## SERVICE BULLETIN

ENGINE - FUEL AND CONTROL - TO PROVIDE A NEW ELECTRONIC ENGINE CONTROL (EEC) WITH THE  
SCN12A SOFTWARE CONFIGURATION - CATEGORY CODE 4 - MOD.ENG-73-0037

# V2500-ENG-73-0037

## ENGINE FUEL AND CONTROL - EEC150-1 ELECTRONIC ENGINE CONTROL - INCORPORATION OF NEW SOFTWARE CONFIGURATION

Location of Electronic Engine Control (EEC)  
Fig.1

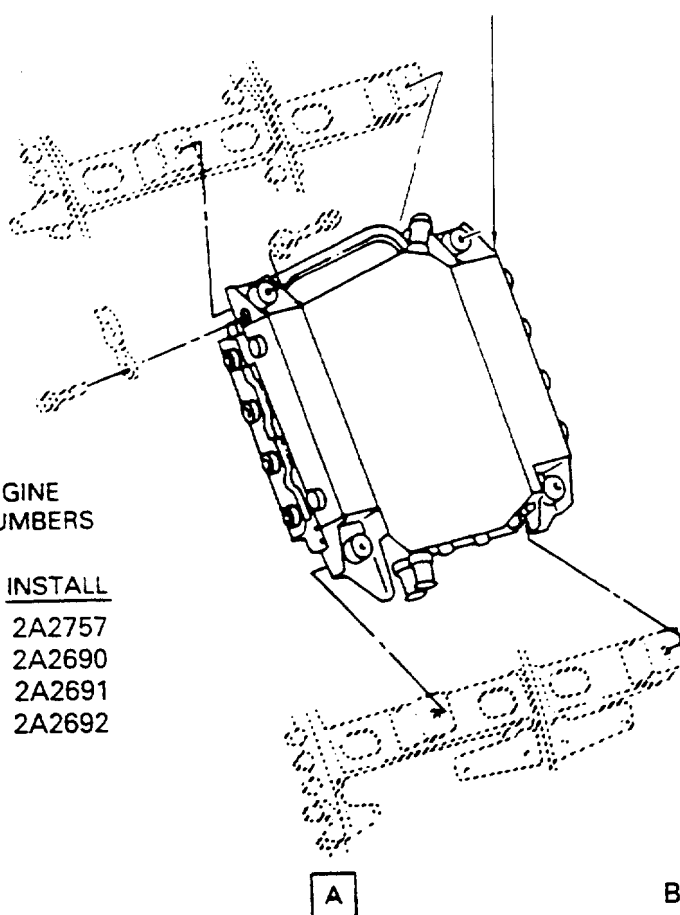
REMOVE THE APPLICABLE PART NUMBER\*  
ELECTRONIC ENGINE CONTROL, DO A  
MODIFICATION, IDENTIFY AND INSTALL  
THE APPLICABLE PART NUMBER \*  
(1 Off)

<u>REMOVE</u>	<u>INSTALL</u>
2A2475	2A2757
2A2478	2A2690
2A2479	2A2691
2A2480	2A2692

- (1) Install the 2A2690, 2A2691, 2A2692, or 2A2757 Electronic Engine Control (1 off) by the approval procedure given in Reference (4), Chapter/Section 73-22-34, Removal/Installation. See Figure 1.

Location of ACC Front Duct Cover Assembly  
Fig.2

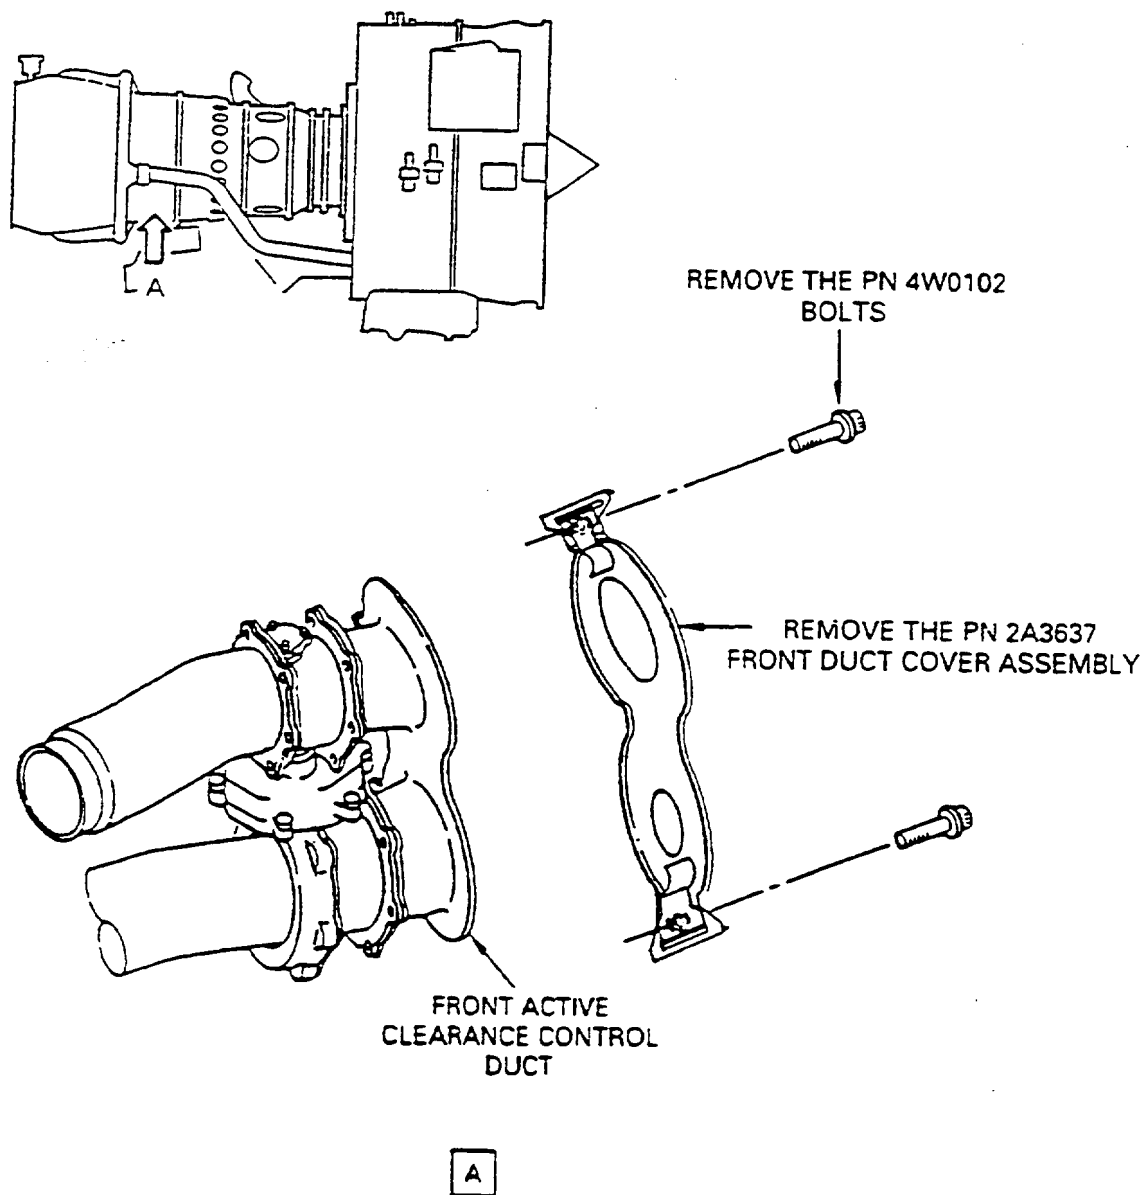
- (a) Send the Electronic Engine Control to the approved vendor to be modified. See Figure 1.
- (2) Remove the Active Clearance Control (ACC) Front Duct Cover Assembly. Refer to Reference (1) and Figure 2.
- (a) Locate the Front ACC Duct.
- (b) Remove the two 4W0102 Bolts from the Front Duct Cover Assembly.
- (c) Remove the 2A3637 Front Duct Cover Assembly.

NOTE: When you incorporate this Service Bulletin with the new SCN12A software logic, the Front Duct Cover Assembly given in Reference (1) must be removed.
